RESPONSIVENESS SUMMARY

Turnbull Landfill Site, Orchards

Draft Second Periodic Review Report

Comment # 1: Letter from the City of Vancouver

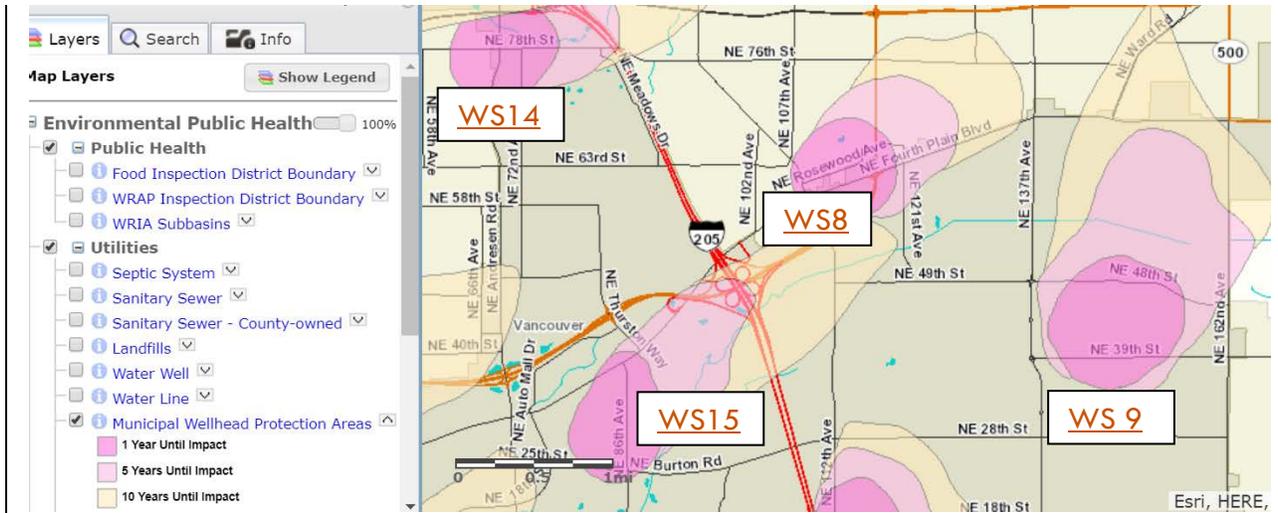
In addition, the landfill is situated upgradient of WS8 within the one-year travel time. The figure below, excerpted from the Clark County Maps Online, illustrates the groundwater travel paths for nearby municipal water supplies.

Vancouver Water Stations and Wellhead Protection Areas

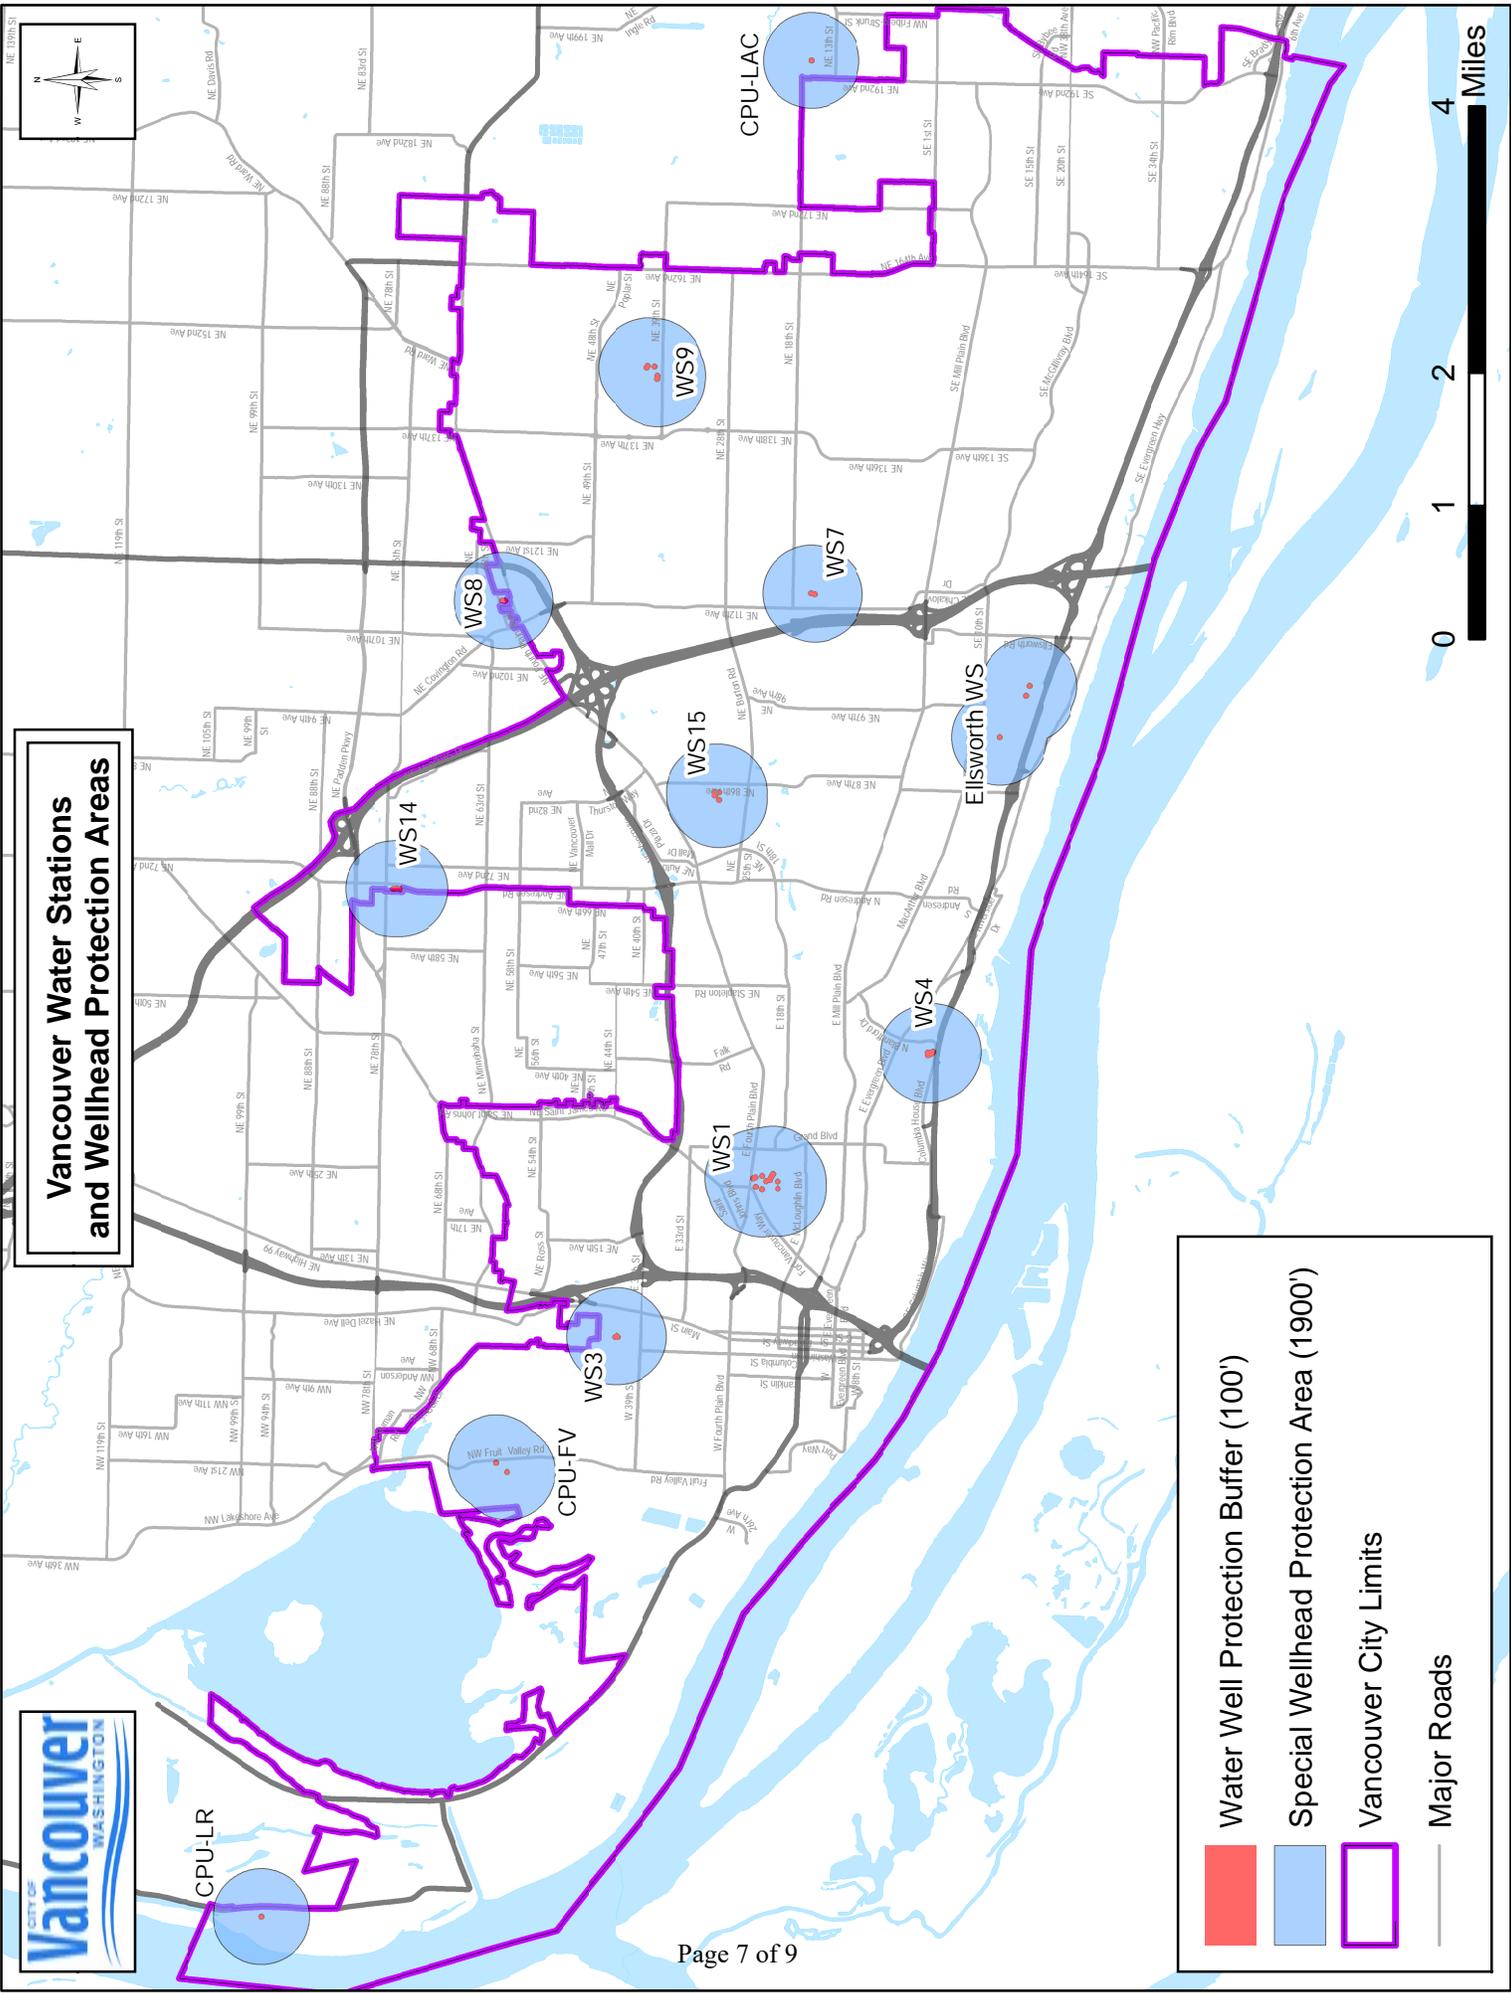
The site sits within a Special Protection Area for City of Vancouver Water Station (WS) 8 with two active municipal supply wells, see *attached WRPO Map*. WS 8 supplies roughly 4.0% of the City's drinking water supply.

Thank you for taking the time to review the draft periodic review report and providing the Department of Ecology (Ecology) with your comments. Based on your comments, Ecology understands that the Turnbull Landfill Site (Site) is situated upgradient of the City of Vancouver (City) Water Station (WS) 8 with two water supply wells. We also understand that these water supply wells are located within the one-year travel time in a Special Protection Area of WS 8 downgradient from the Site.

Since no contamination was detected both in soil and groundwater (except manganese below MTCA Method B cleanup level) and due to the type of wastes disposed of at the Site, Ecology believes that it is highly unlikely that the Site will pose any risk to the WS 8 public water supply wells located down-gradient of the Site. In addition, since no contamination was detected in the groundwater above MTCA Method A or Method B cleanup levels at the Site, the groundwater monitoring wells were decommissioned as per WAC 173-160 requirements.
